City of Fenton  
 Old Highway 141 Bridge Value Engineering Proposal  
 Final VE Quantities  
 3/29/2011

**OLD HIGHWAY 141  
ROADWAY IMPROVEMENT PLANS**  
FENTON, MISSOURI  
Prepared For:  
**CITY OF FENTON**

**Re: Value Engineering of Fenton Creek Bridge Replacement  
Project No. BRM-4989(606), Bridge No. 1420013  
Response to Review Comments and Revised Final Plans**

GENERAL PLAN AND ELEVATION

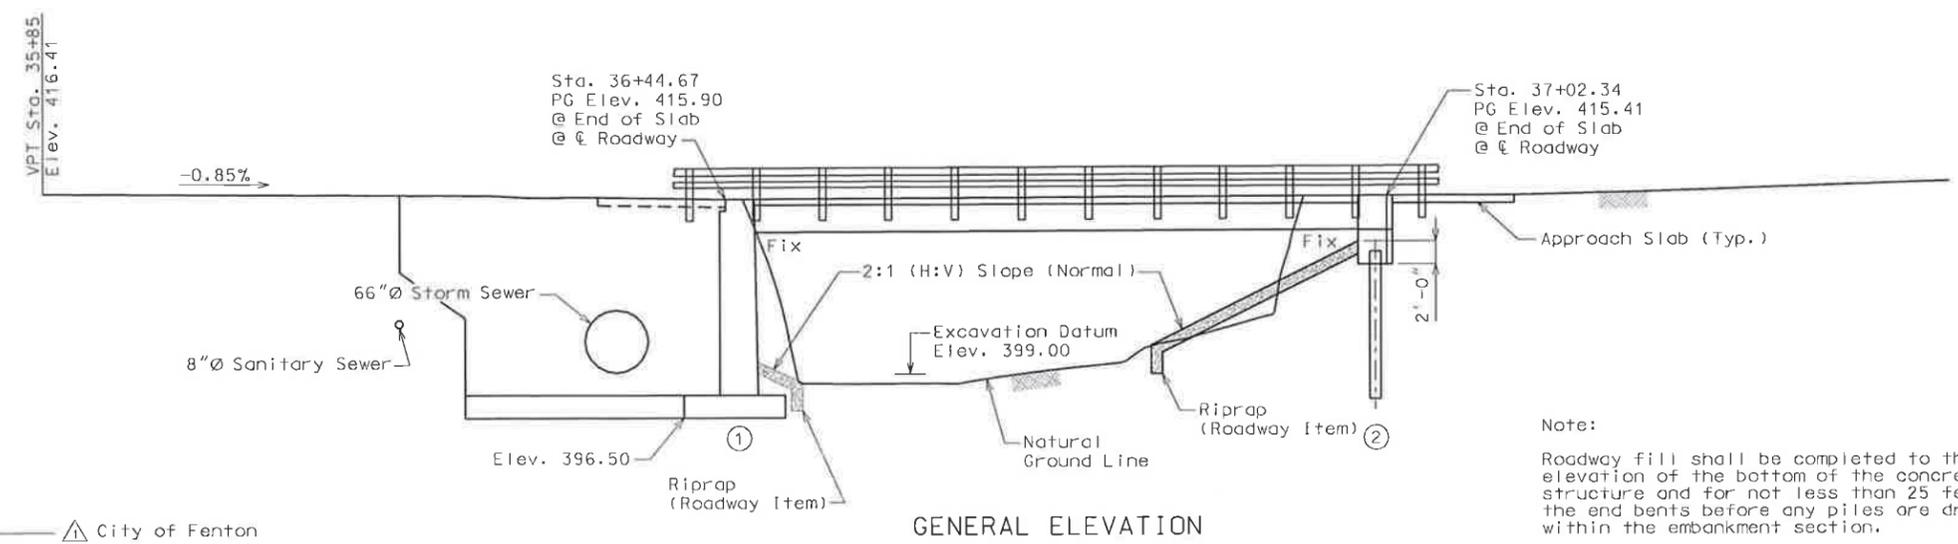
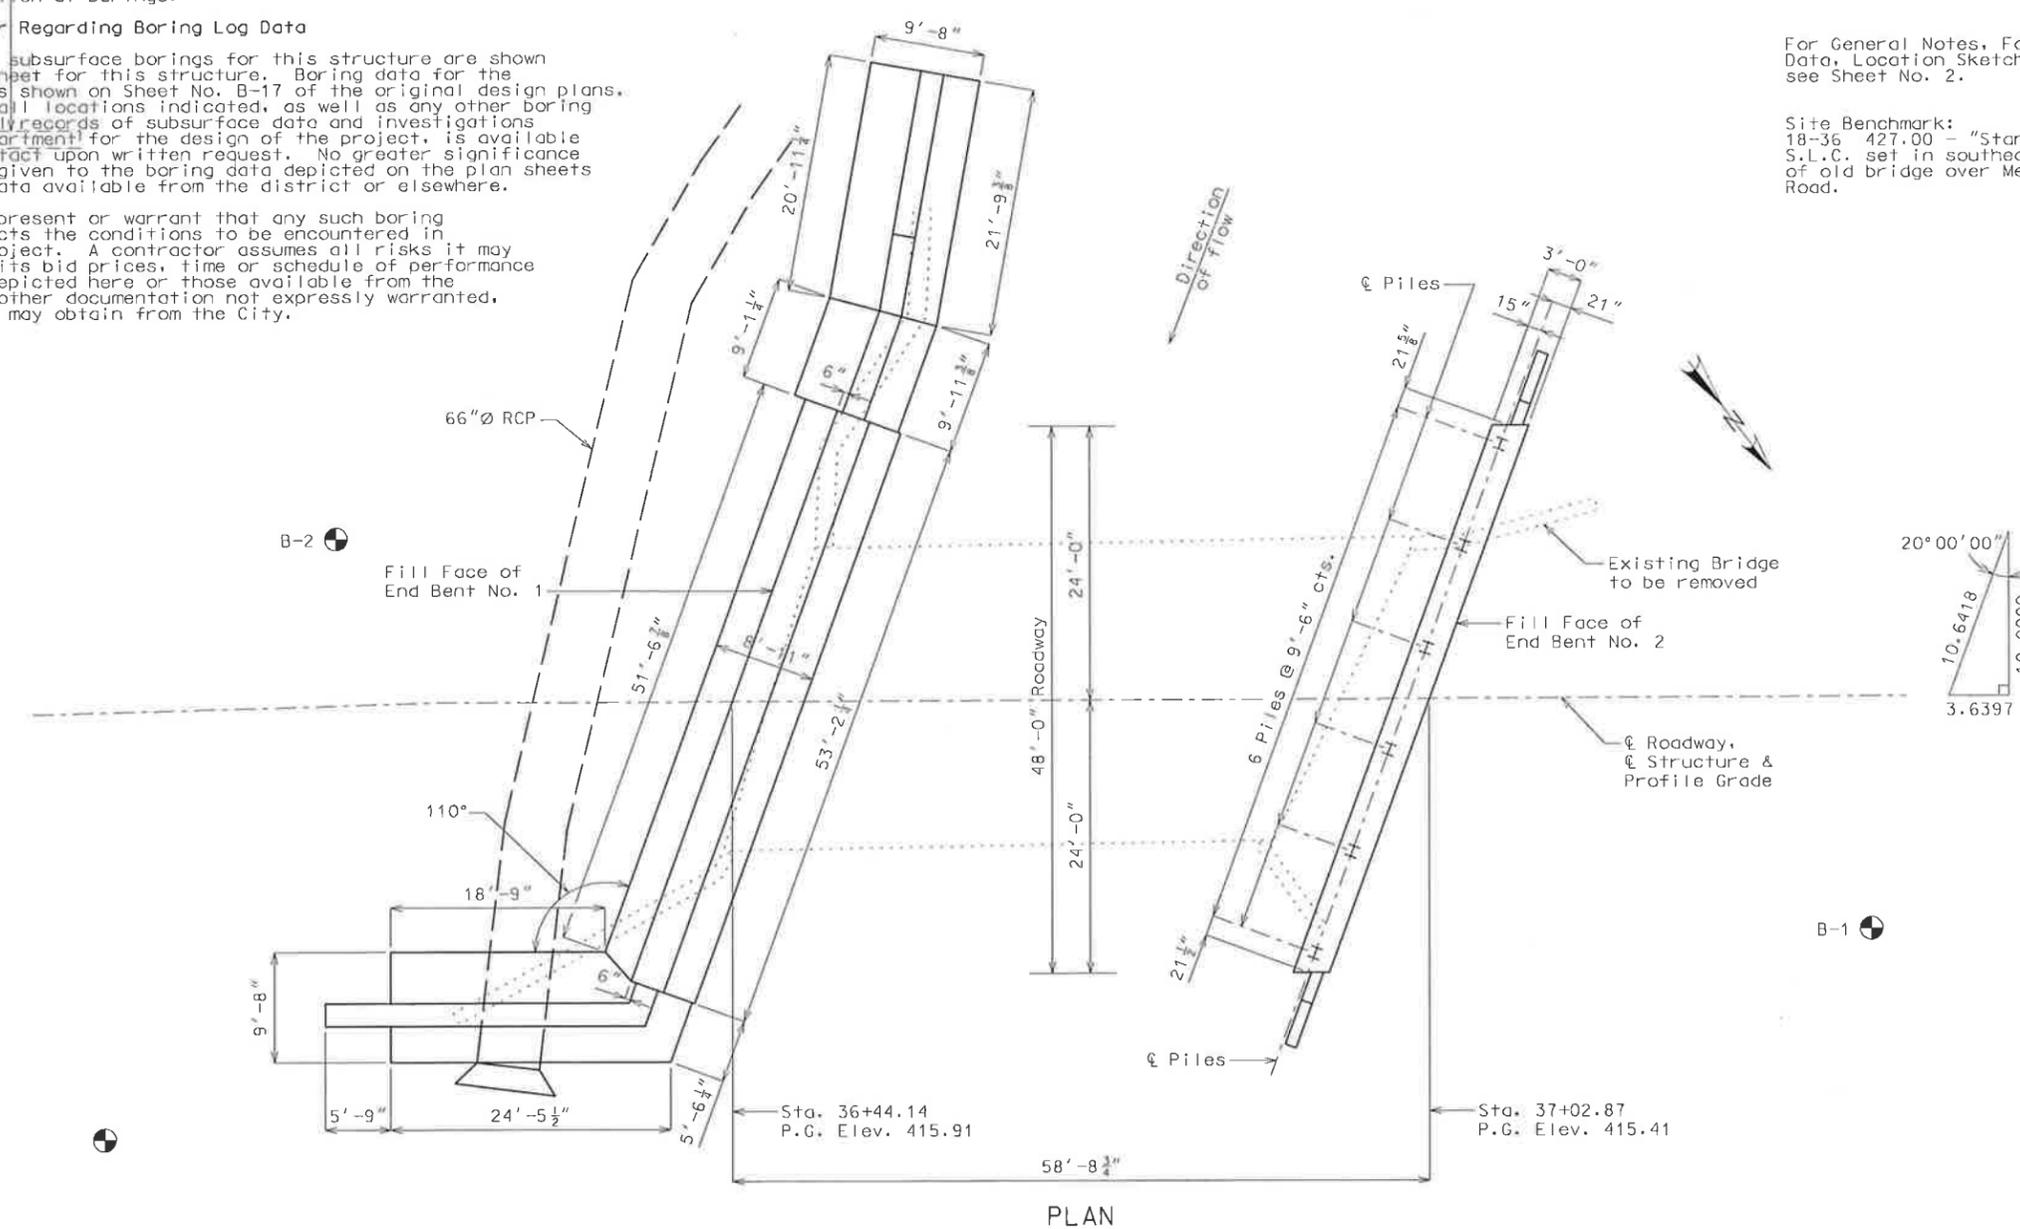
8. "Notice and Disclaimer Regarding Boring Log Data" should refer to the *City of Fenton*, not *department* or *district*. **Plans revised accordingly.**

The Hydrologic Data Table is taken from Drawing B-2 of the original design plans and is included here for information only.

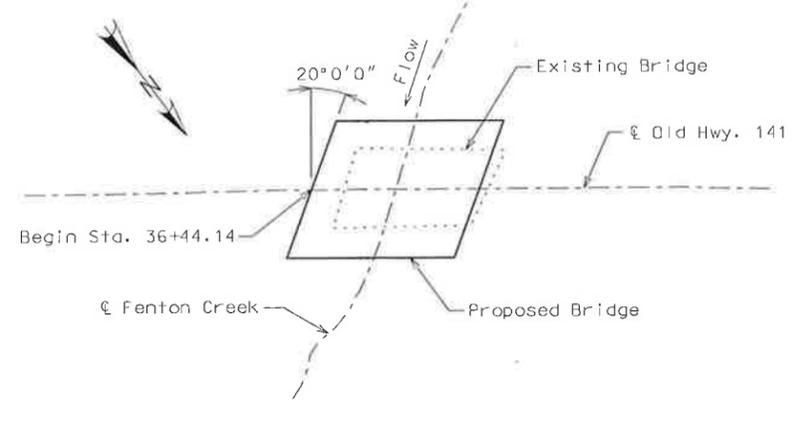
9. Add Hydrologic Data table shown on Woolpert Drawing B-2 and identify this table as "taken from Drawing B-2 of the original design plans". **Plans revised accordingly.**
10. All excavation above the Excavation Datum (defined as Elev. 399.00 on Sheet No. 1) is Class 1 Excavation. Where is Class 1 Excavation in Rock? Is this a placeholder quantity? Quantity calculations indicate 10 CY pulled out of Class 1 with no further explanation.

DETAILS OF END BENT NO. 1  
SHEET 1 OF 5

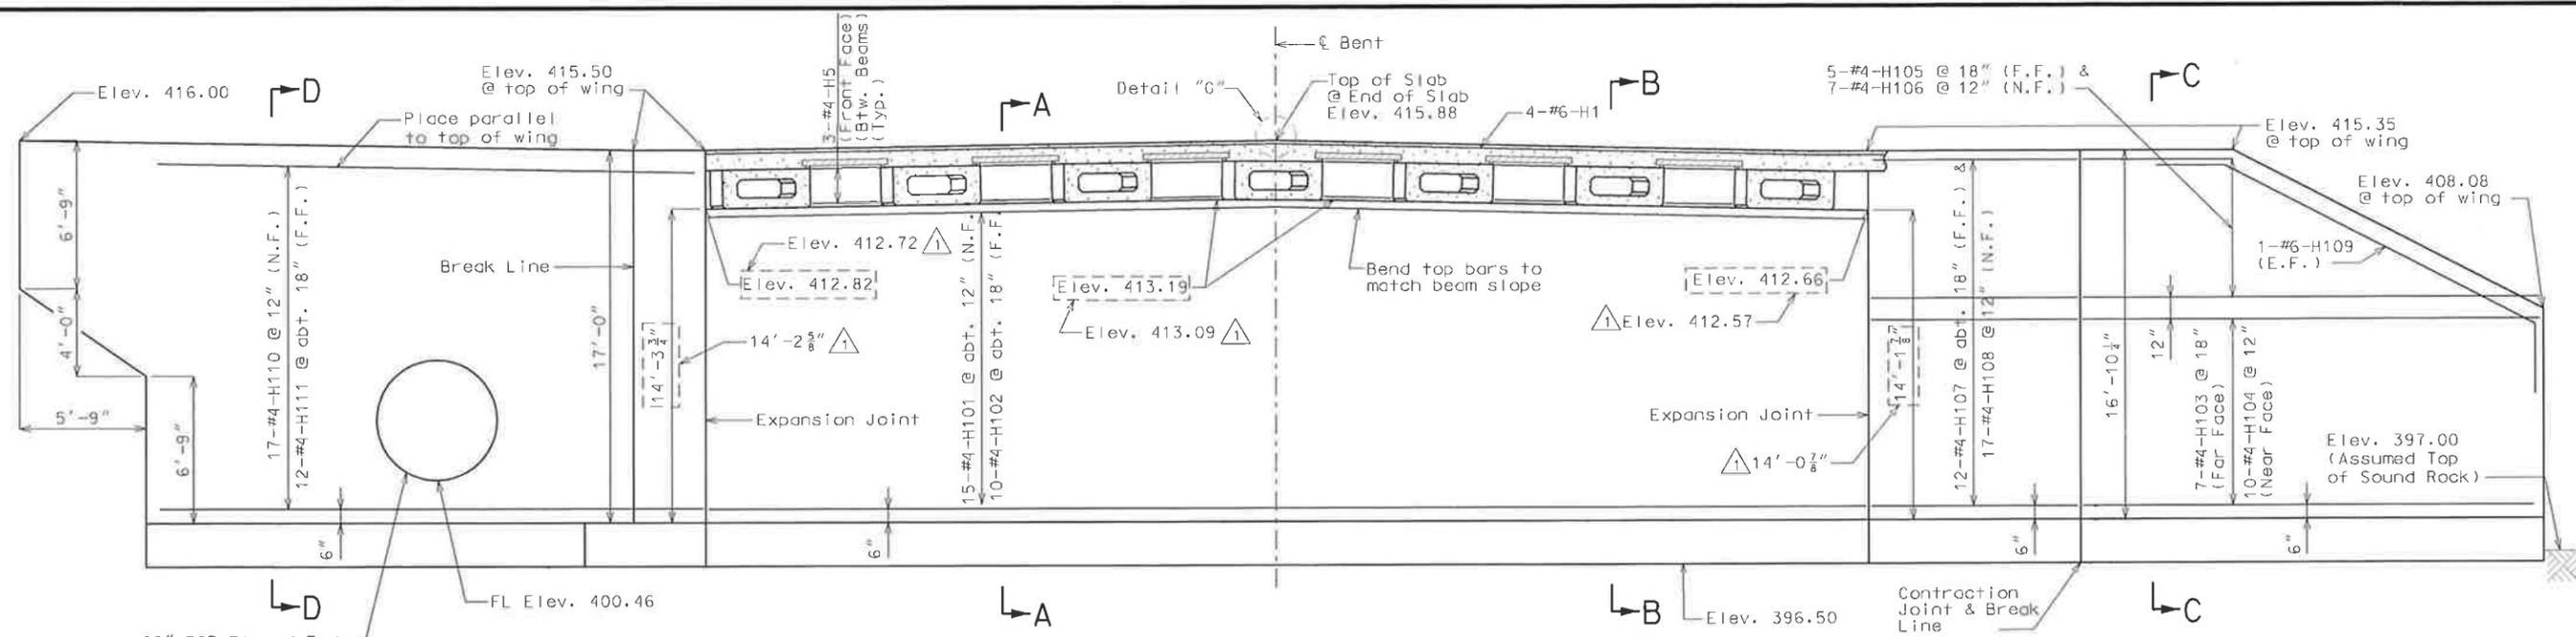
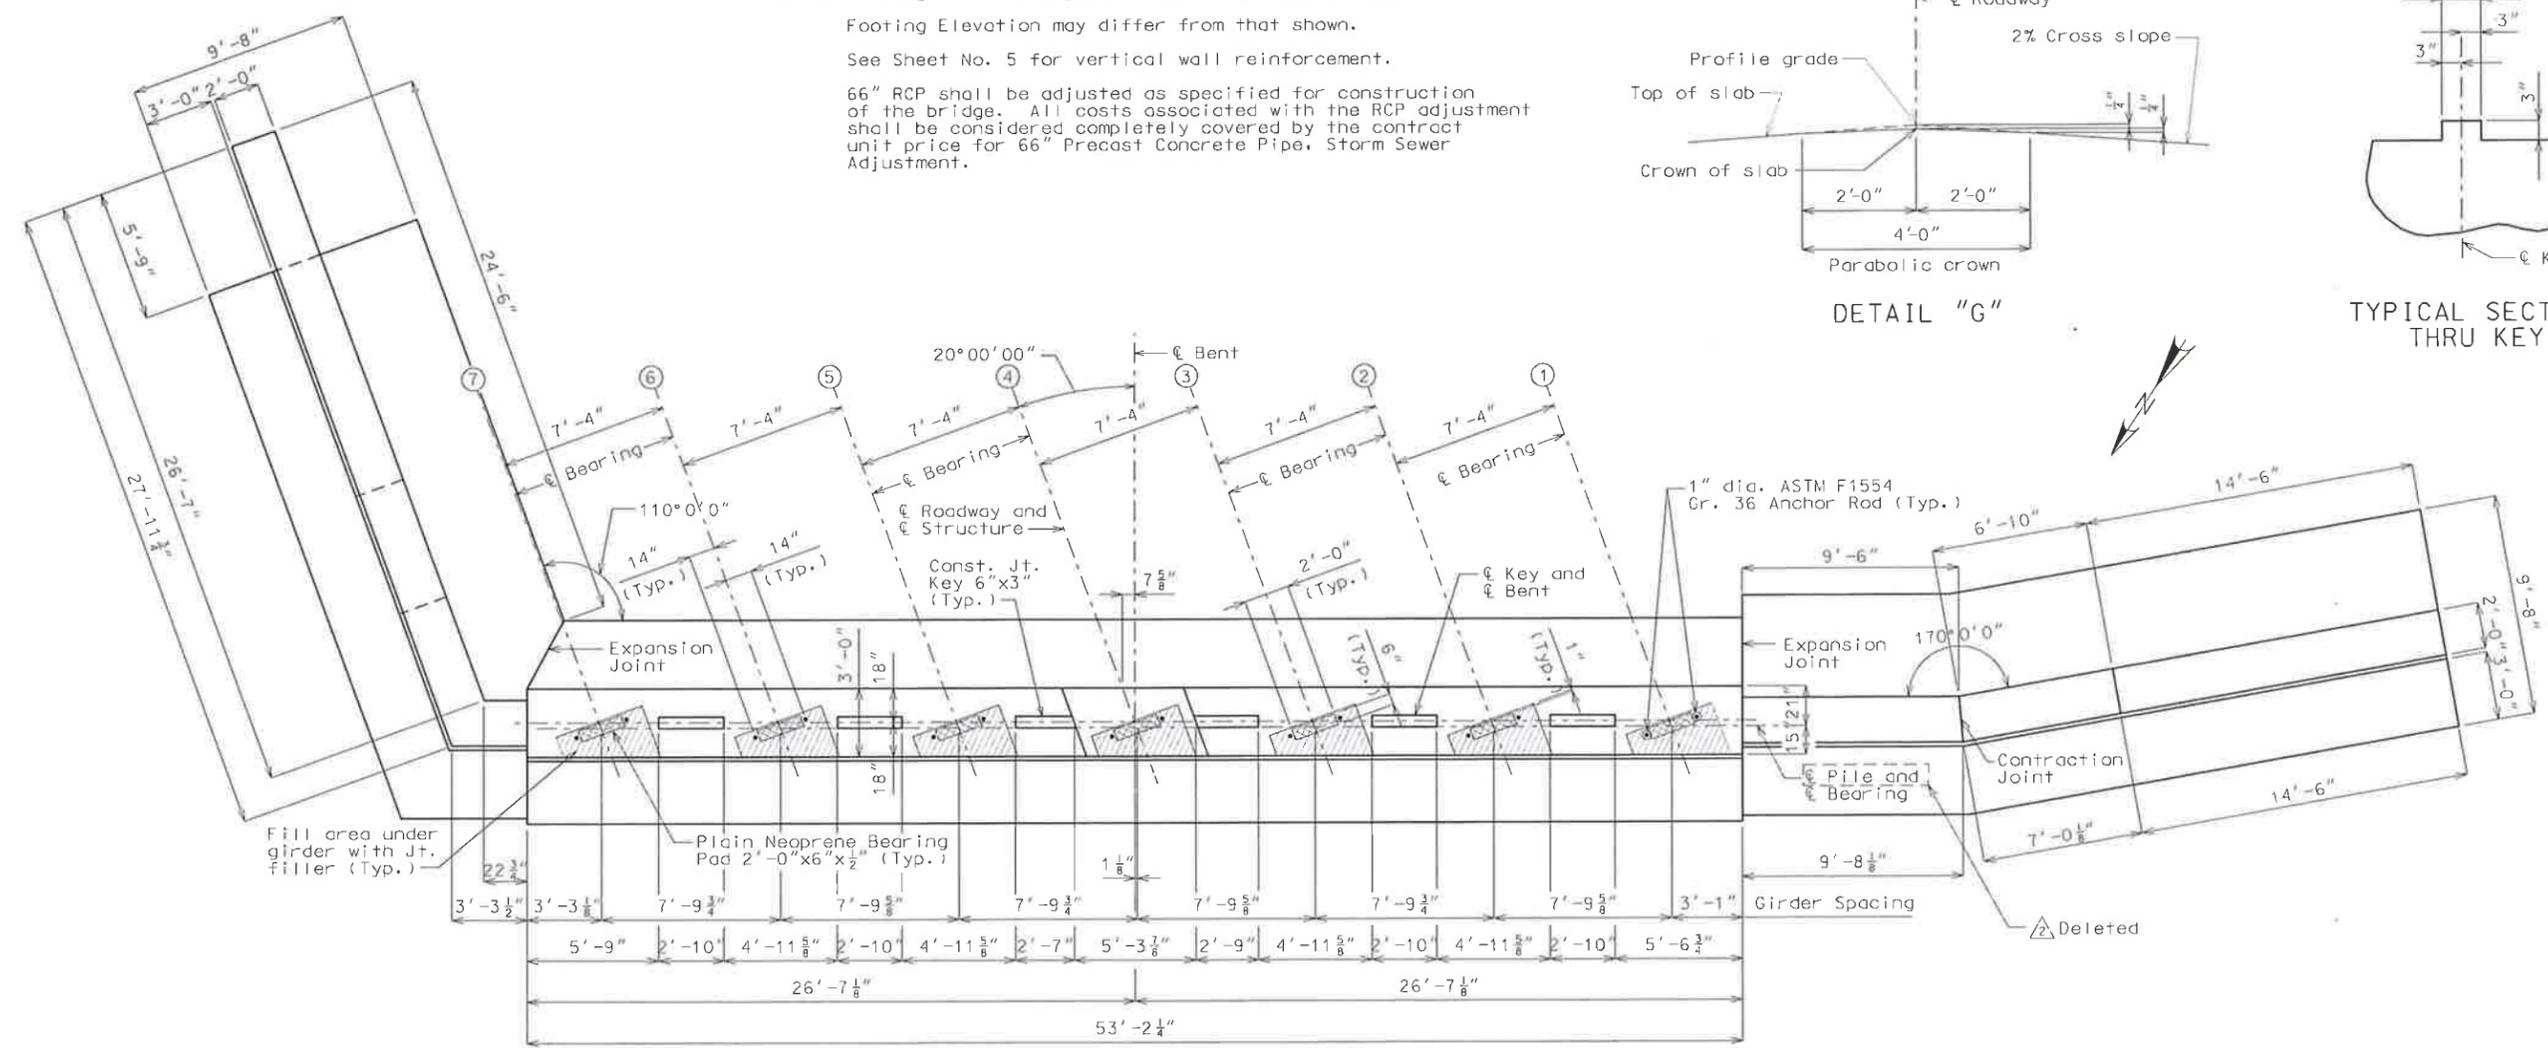
18. Revise callout in PLAN OF BEAM SHOWING DIMENSIONS to remove reference to *Centerline Pile*. **Plans revised accordingly.**
